PRODUCT/PROCESS CHANGE NOTICE (PCN)

PCN #: TB1403-01 DATE: April 9, 2014 Product Affected: TSSOP-14, TSSOP-16 shipped in Tape & Reel (Refer to Attachment II for affected part#) Date Effective: July 9, 2014	MEANS OF DISTINGUISHING CHANGED DEVICES: <input type="checkbox"/> Product Mark <input type="checkbox"/> Back Mark <input type="checkbox"/> Date Code Shipment starting from July 9, 2014 <input checked="" type="checkbox"/> Other
---	--

ATTACHMENT I - PCN #: TB1403-01

Detail of Change: This notification is to advise our customers that IDT has planned to standardize the following items on TSSOP-14 and TSSOP-16 to only one type as detailed below.

Figure1: Illustration of Carrier Tape Pocket Dimensions

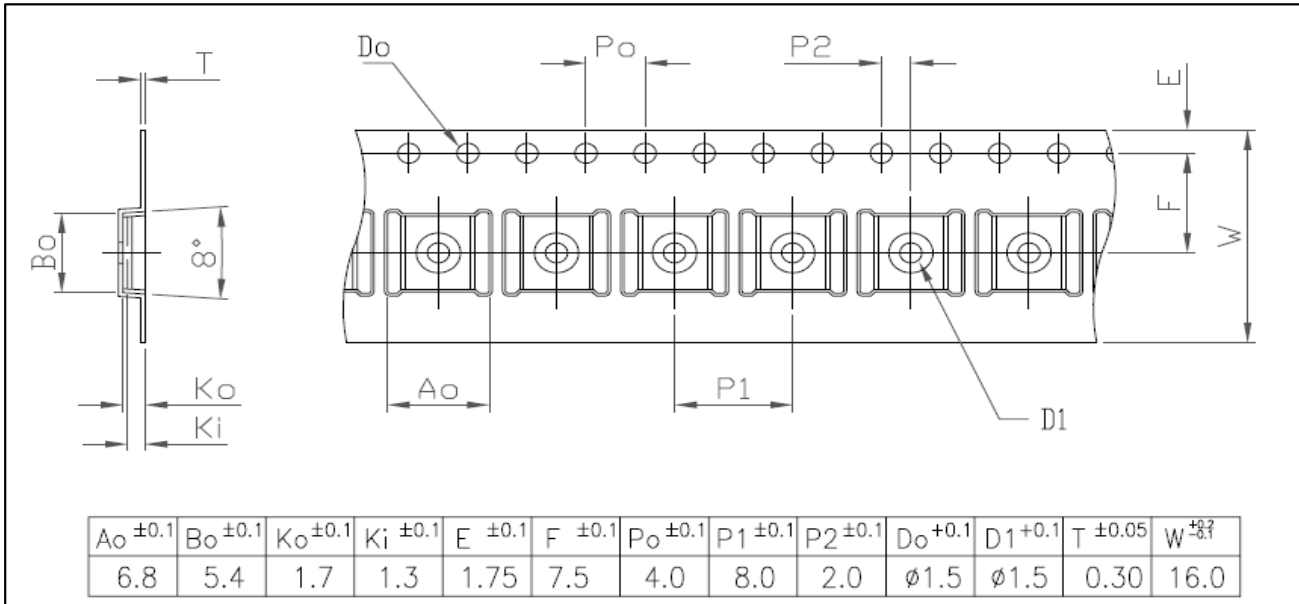
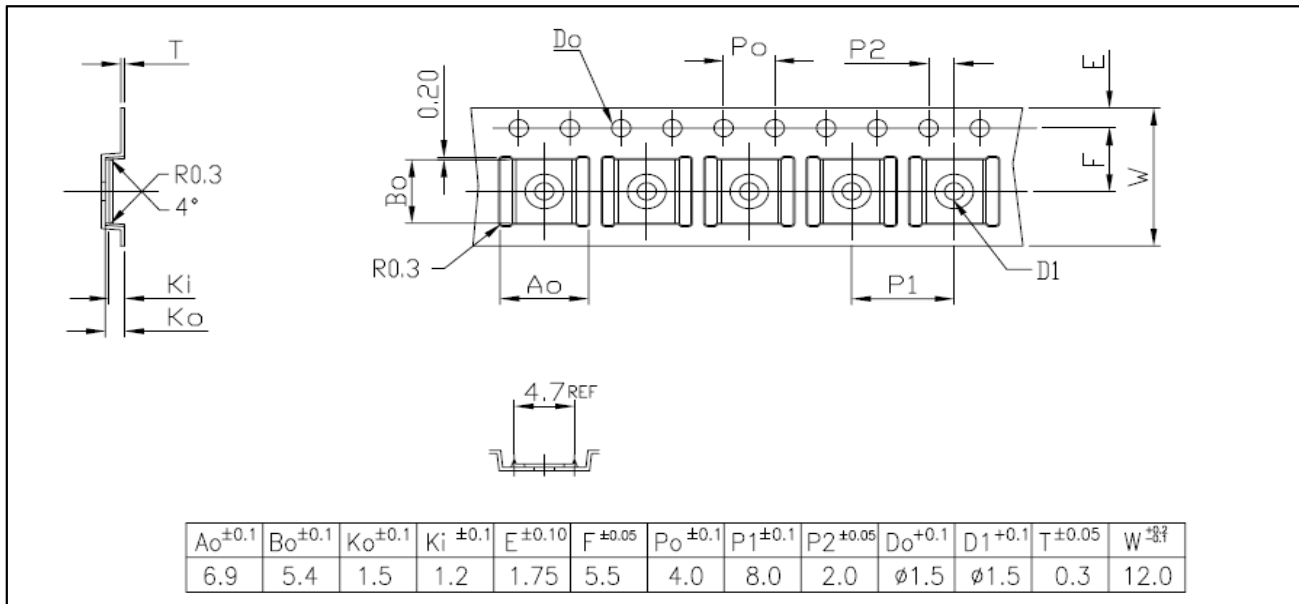
From: Carrier Tape (P8-195-P16) - Pocket Dimensions

To: Carrier Tape (P8-290-P16) - Pocket Dimensions

Figure2: Illustration of Carrier Tape Pocket Design

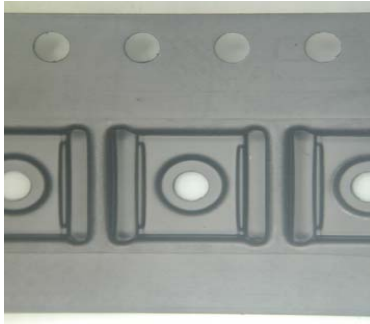
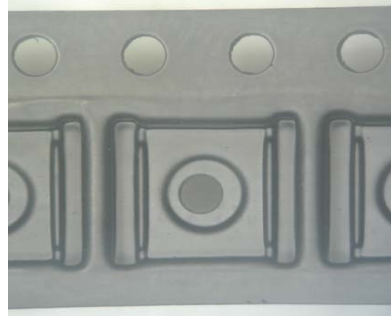
From: Carrier Tape (P8-195-P16)

To: Carrier Tape (P8-290-P16)

Figure3: Illustration of Plastic Reel

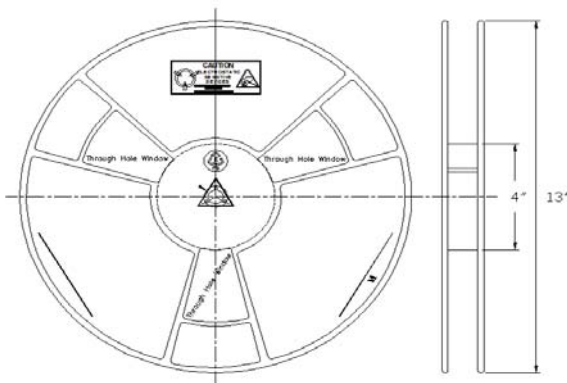
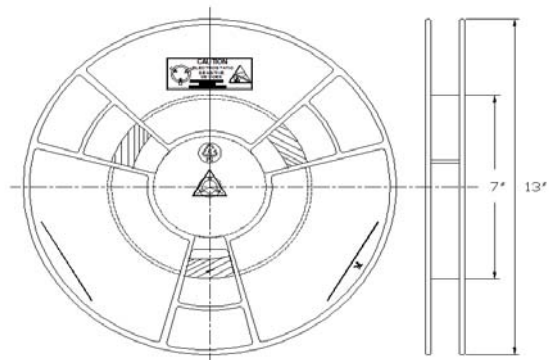
From: 13"/4" Hub Plastic Reel

To: 13"/7" Hub Plastic Reel
